CITY OF LAS VEGAS INTER-OFFICE MEMORANDUM		DATE: June 24, 2021
TO: Land Development Services Department of Building & Safety		FROM: Jennifer Shinn, P.E.  Flood Control, Engr. Associate Department of Public Works
SUBJECT:	Drainage Study for: 8th and Franklin	COPIES TO: TCE
Cross Streets:	SEC of 8 th Street and Franklin Avenue	Kavison Homes
File Number:	F:\Depot\DSMemos\DS5448B.doc	Bart Anderson, P.E., DevCo
Parcel Number:	162-03-604-004	
Zoning Action:	20-0247-TMP1	
FEMA Flood Zone	YES	NO X
Proposed Storm Drain	YES	NO X

ADDENDUM #1 TECHNICAL DRAINAGE STUDY FOR 8th AND FRANKLIN

Re: Addendum #1 to the Technical Drainage Study for 8th and Franklin

DEVELOPED BASINS
FIGURE 6

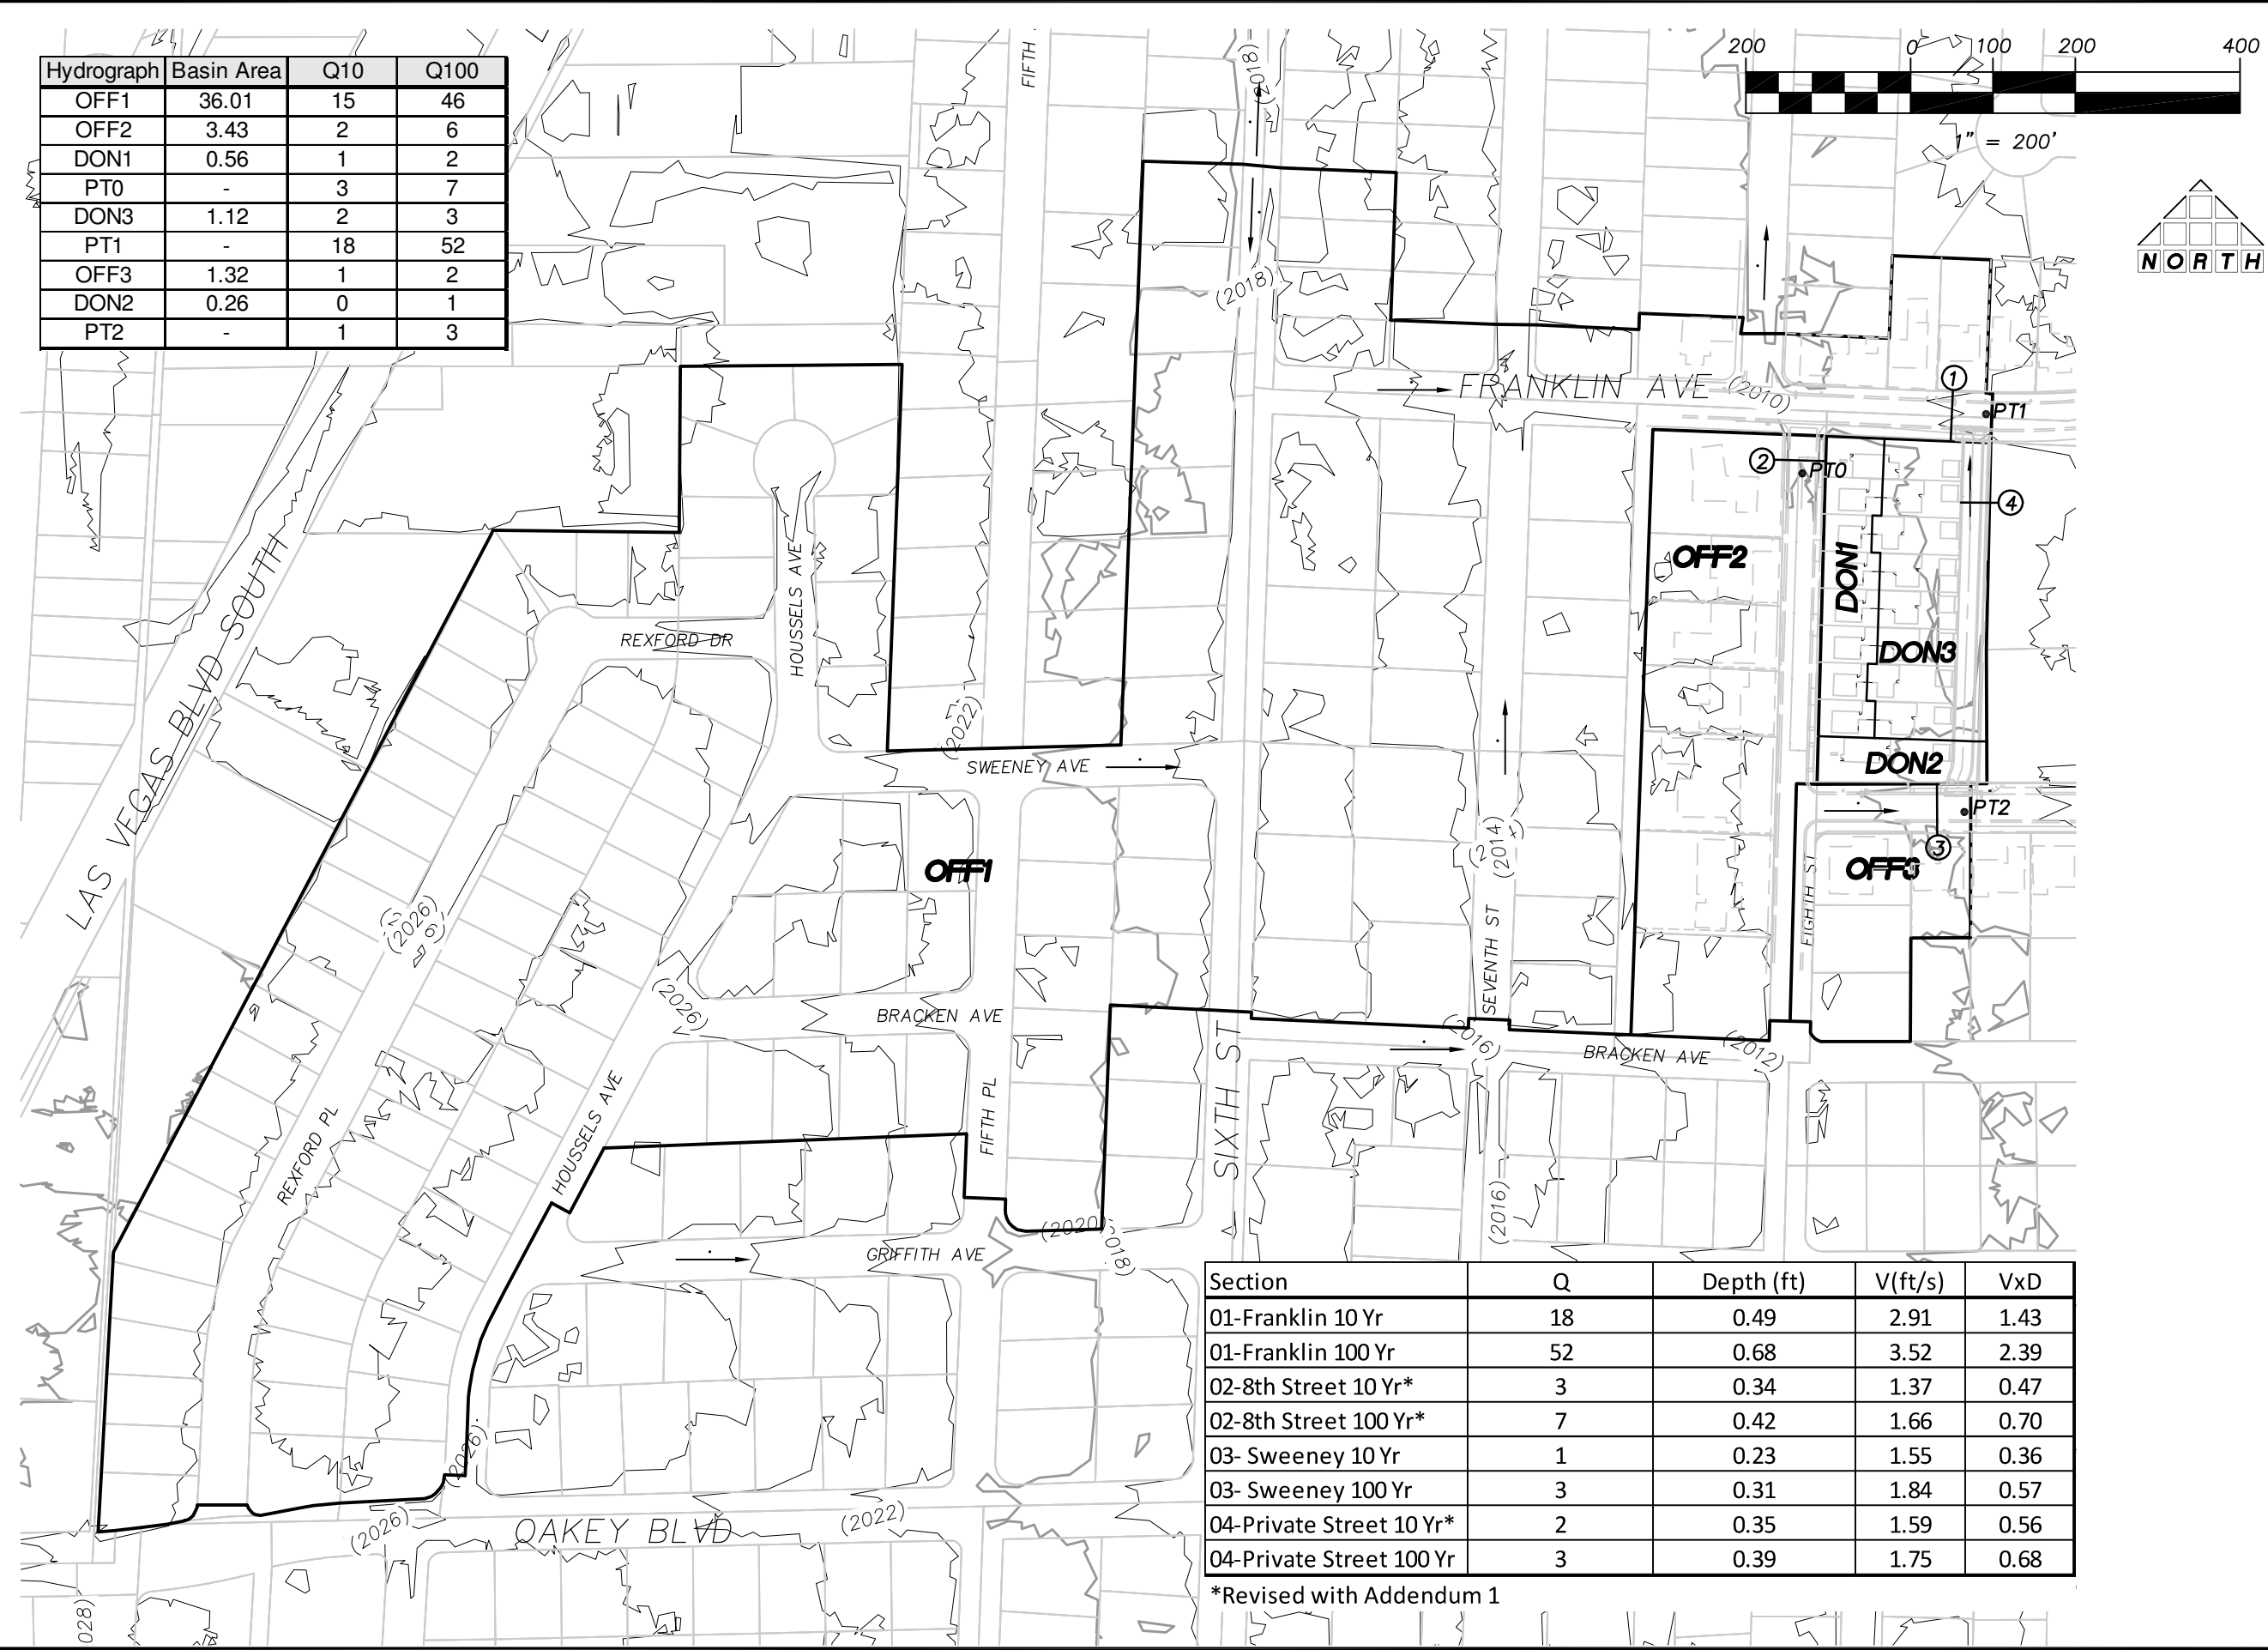
- 4. DON1 is shown as a single basin that discharges to the northeast corner of the subject site. The Grading Plans indicate that half of each lot drains to 8th Street and the other half drains to the Alley. Revise all pertinent calculations models, and plans accordingly.**

The developed condition HEC-1 analysis has been revised to reflect the center lot high points. Revised calculations are included with this addendum.

SHEET **G1** OF 7
 DRAWING NO.

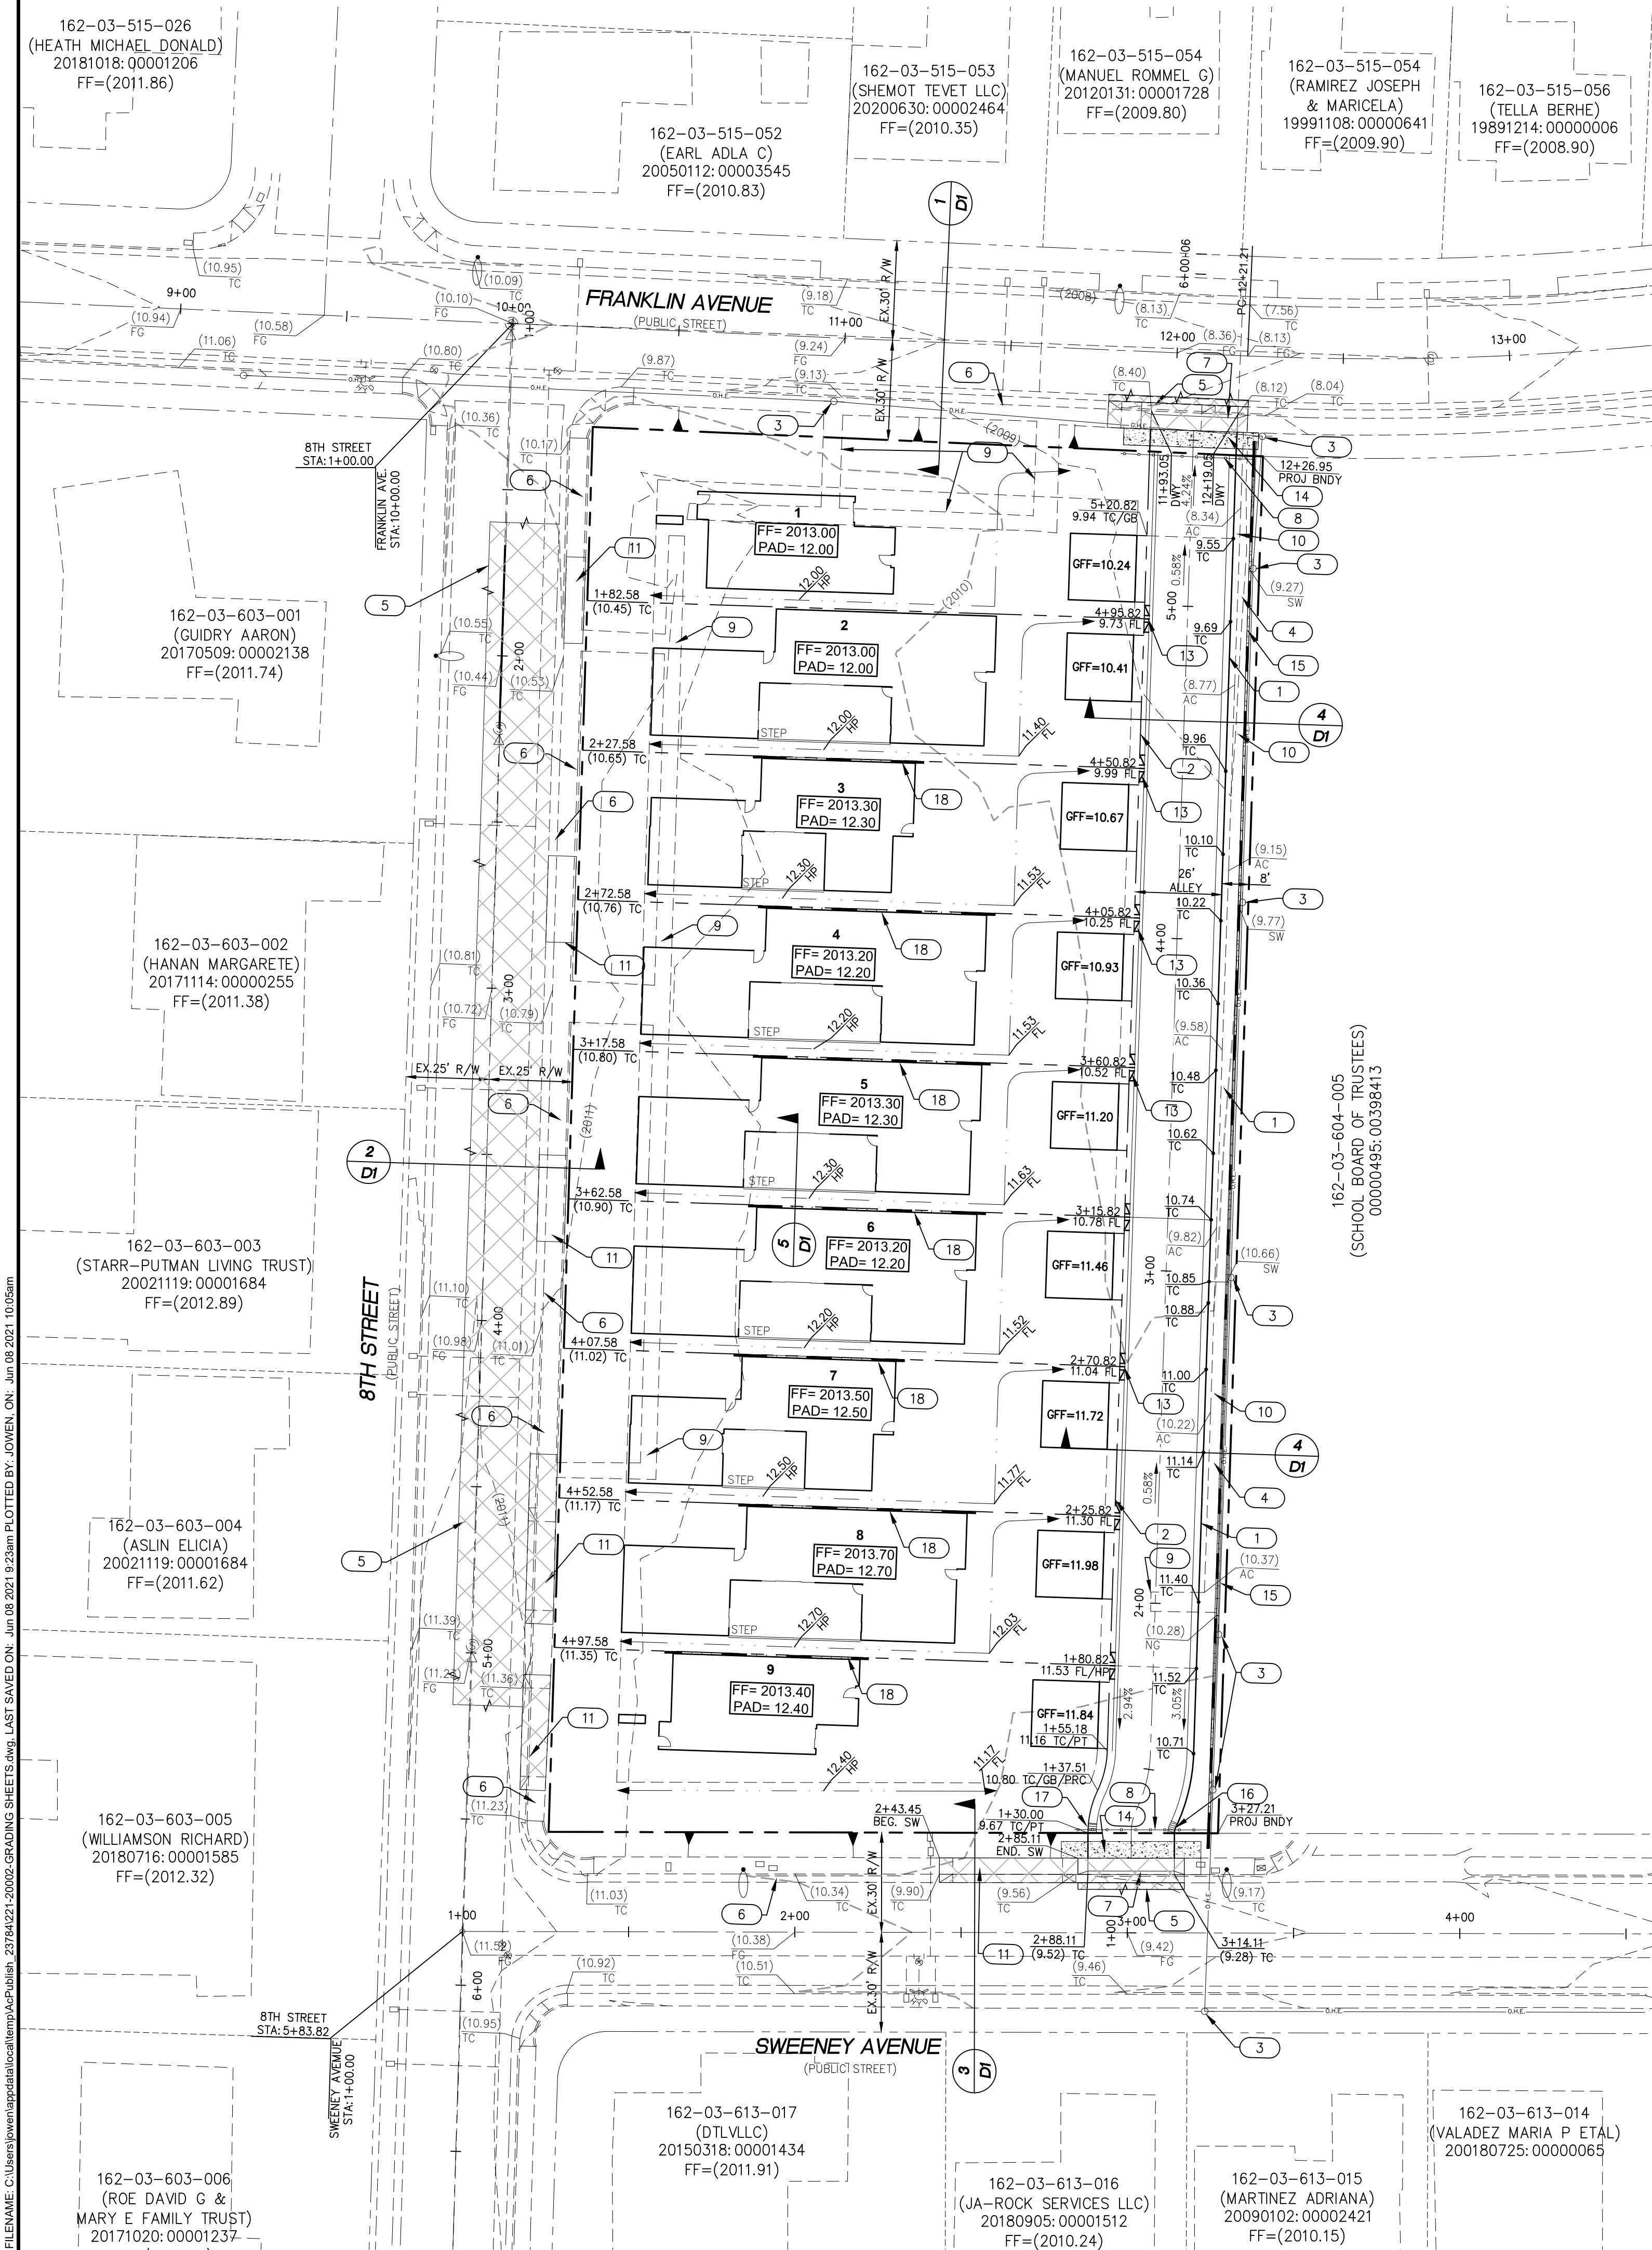
1. Provide a signature line on the Drainage Study Note block on the Grading Plan.

- 2. The following finish floors do not meet the Regional Flood Control District minimum criteria of twice the Q100 depth of flow up to 18-inches above the water surface (CCRFCD Manual Section 304.4.E.1) or 6-inch minimum above the highest adjacent top of curb (CCRFCD Manual Section 1602 304.4.E.1). The following finish floors should be revised to alternate flood protection provided.**

Lot	FF shown	Min FF
8	2011.43	2011.85 (6" min. above high side TC)
9	2011.61	2011.85 (6" min. above high side TC)

- 3. The proposed residential project consists of lots with 5'-long driveway leading into the individual garage and finish floor. In comparison to the traditional residential lots, normally with 20'-long driveway leading to the garage, a minimum of 0.5' freeboard from the garage elevation to the adjacent top of curb is provided. In the next submittal, revise the garage elevation (GFF) at all lots such that a minimum of 0.5' freeboard is provided with relation to the adjacent high side TC.**

- 5. Provide the standard drainage compliance note on the grading plan: "I CERTIFY THAT THIS GRADING PLAN IS IN CONFORMANCE WITH THE APPROVED DRAINAGE STUDY ON FILE AT THE CITY OF LAS VEGAS FOR THIS PROJECT (DS5448)". The project proposed offsite grading in the adjacent property to the east. Obtain a notarized letter of permission for grading from the adjacent property owner(s) prior to final approval of the drainage study.**

The finished floors have been raised to meet criteria.

The alley way is designed with a 2% cross fall and has a depth of flow of 0.39ft. With the cross fall alley, the GFF's are set at least twice the depth of flow above the easterly curb flowline and are adequately flood protected.

The note has been added to the revised grading plan.

DRAINAGE STUDY NOTE
 I CERTIFY THAT THIS GRADING PLAN IS IN CONFORMANCE WITH THE APPROVED DRAINAGE STUDY ON FILE THE CITY OF LAS VEGAS DS#5448.
